P.F. Formation environmental impact statement extractive  
industry, concrete batching plant : Portion 198, Parish of  
Cornelia, Old Northern Road, Maroota

**P.F. FORMATION  
ENVIRONMENTAL IMPACT STATEMENT  
EXTRACTIVE INDUSTRY, CONCRETE  
BATCHING PLANT  
PORTION 198, PARISH OF CORNELIA  
OLD NORTHERN ROAD, MAROOTA**

## ADDENDUM

FIGURE 15.

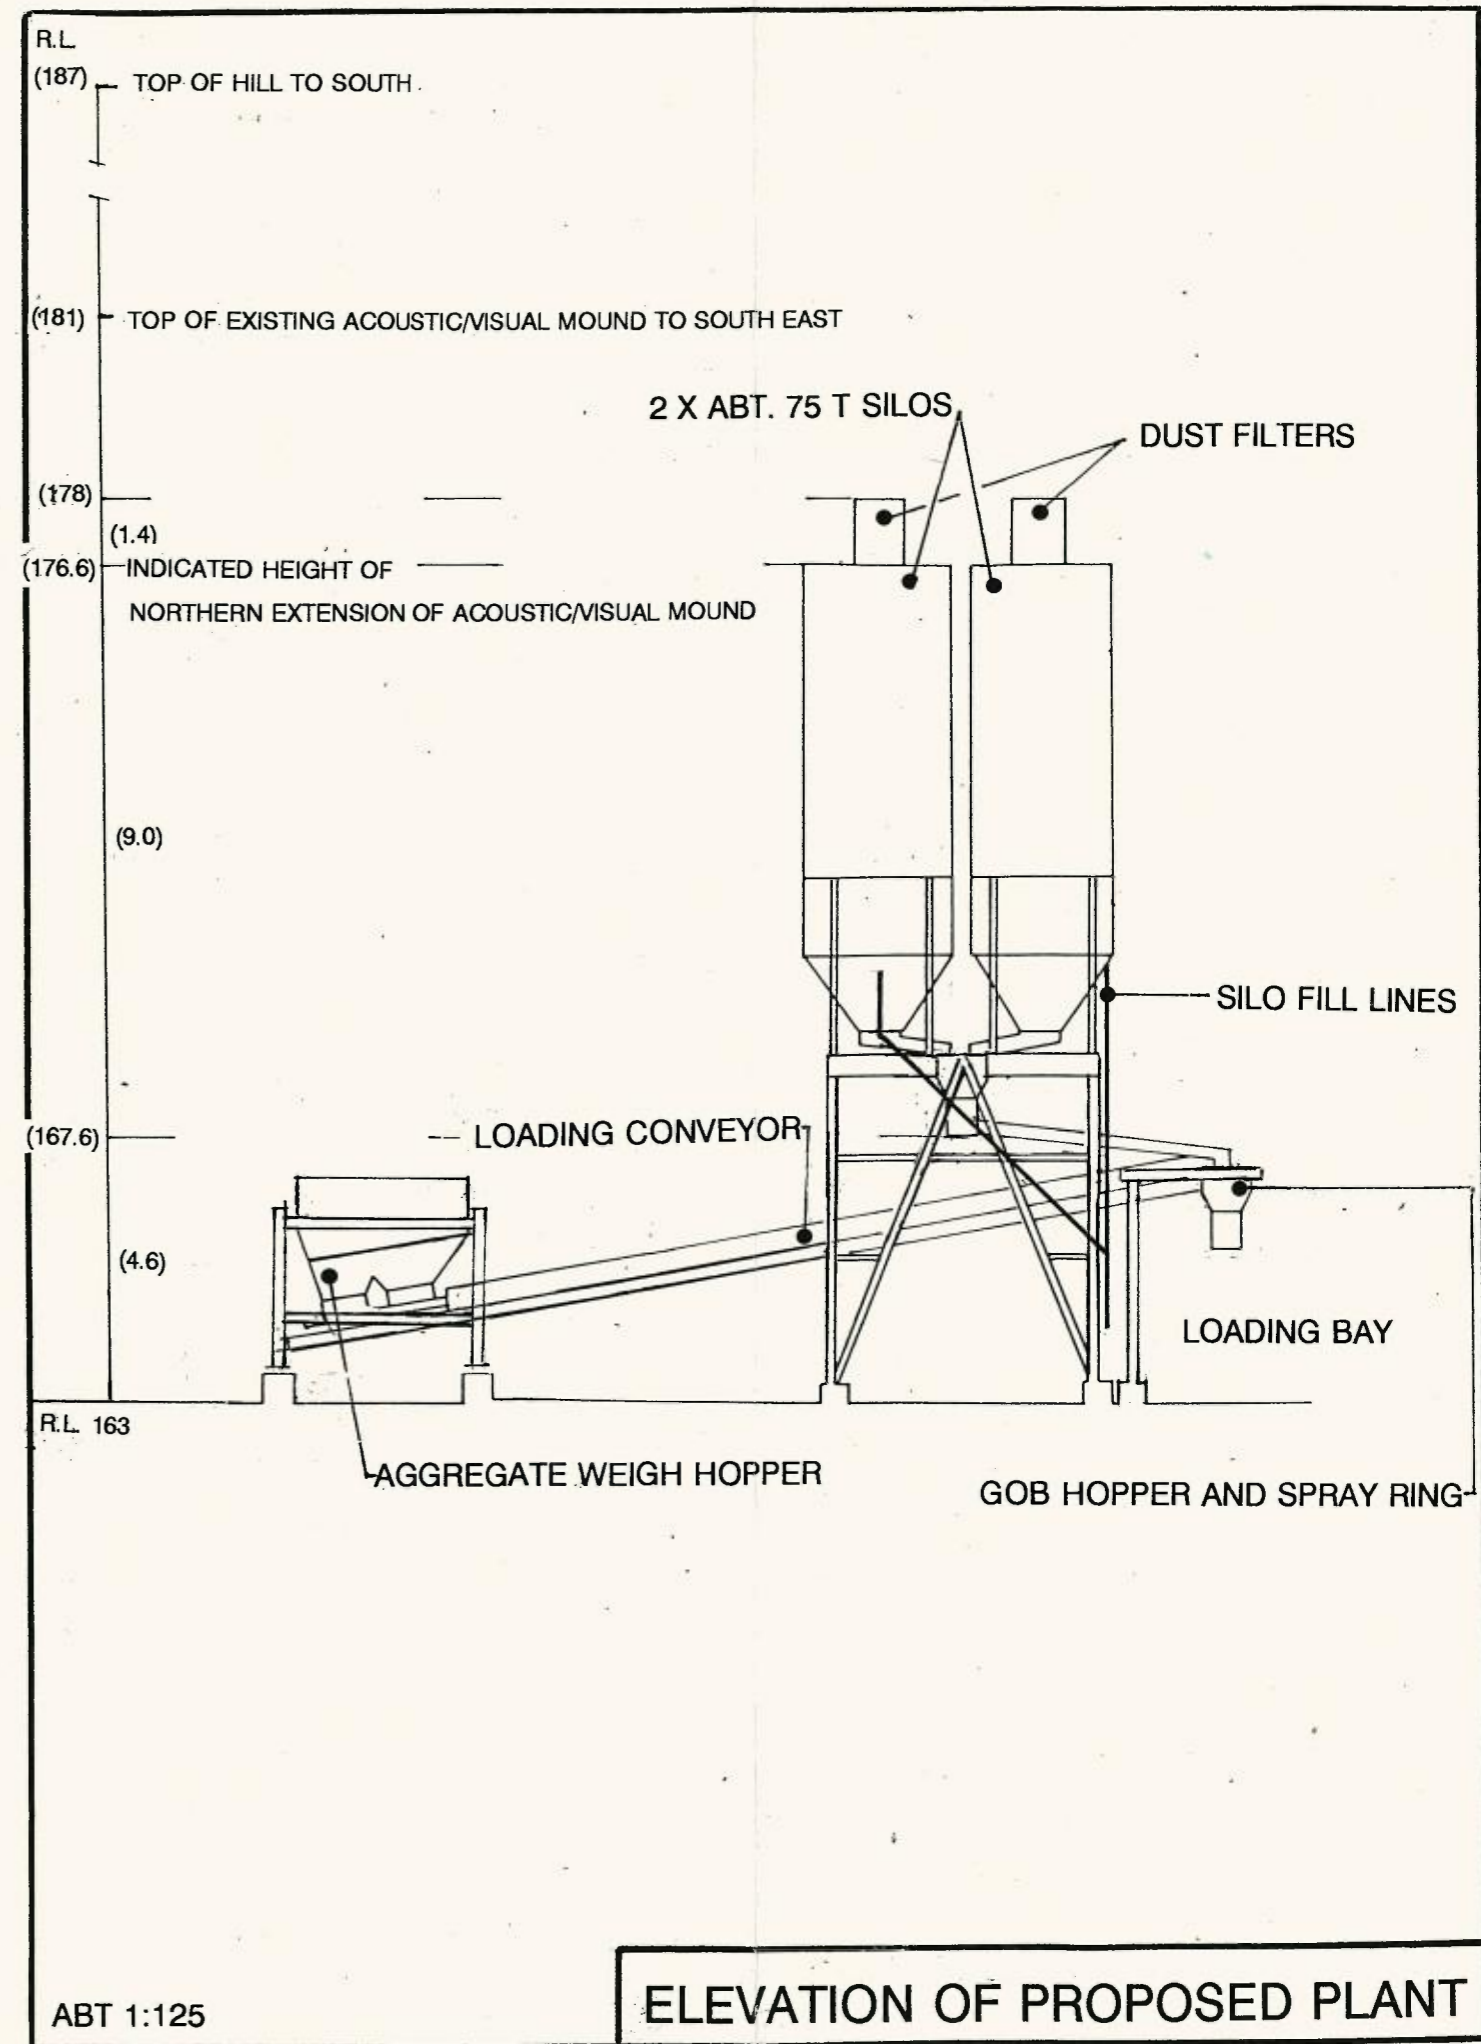
Since completing this E.I.S. the writer has been advised that the two silos to be erected (see Figure 15 and text), will not have individual capacities of 75 tonne.

Readers are now advised that the two silos as now proposed will each be of 30 tonne capacity only, and that, rather than standing 13.5 metres off the floor of the compound they will now have a maximum height of only 12 metres.

Since, within this document, there was some minor concern that the top of the original silos may have been visible from various vantage points, that concern, though only of a minor nature before, is now somewhat even more diminished.

**FIGURE 18**

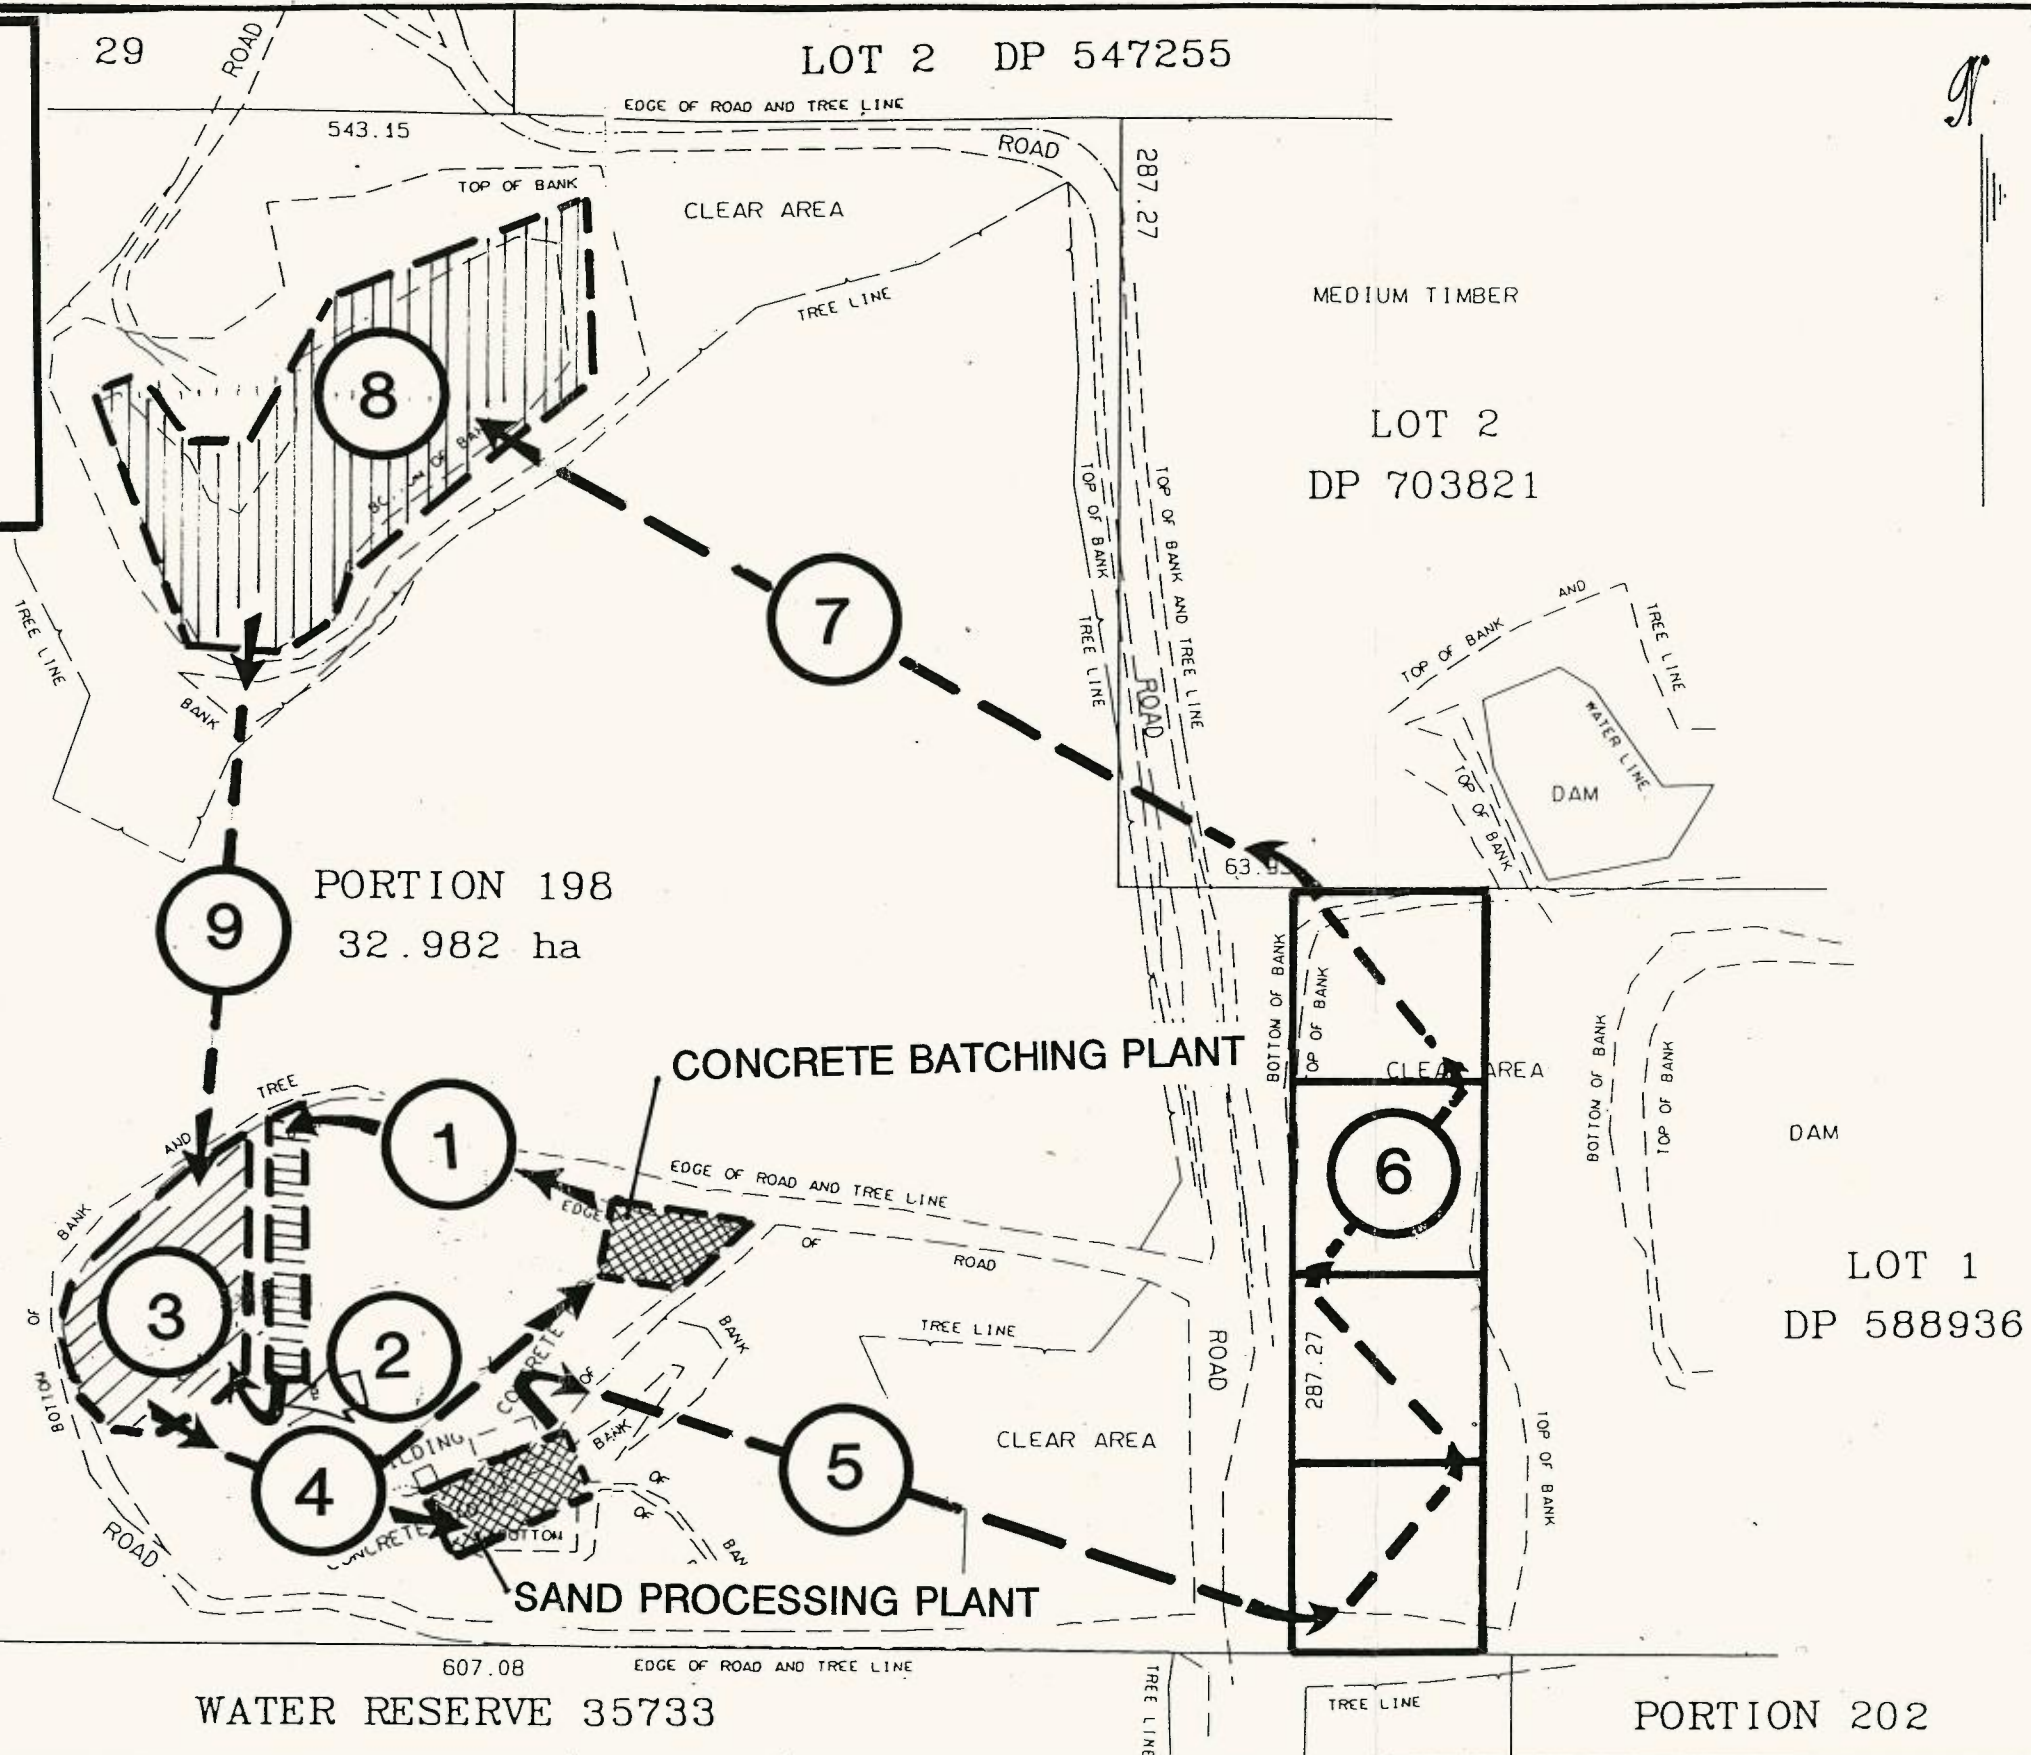
Please also note that any dirty waters which leave any part of the batching plant site will, after passing through a sediment pond system, flow into the 5 million litre wash plant intake dam (see Location No 3 at Figure 18). The capacity of this receptor dam was not referred to in this Statement.
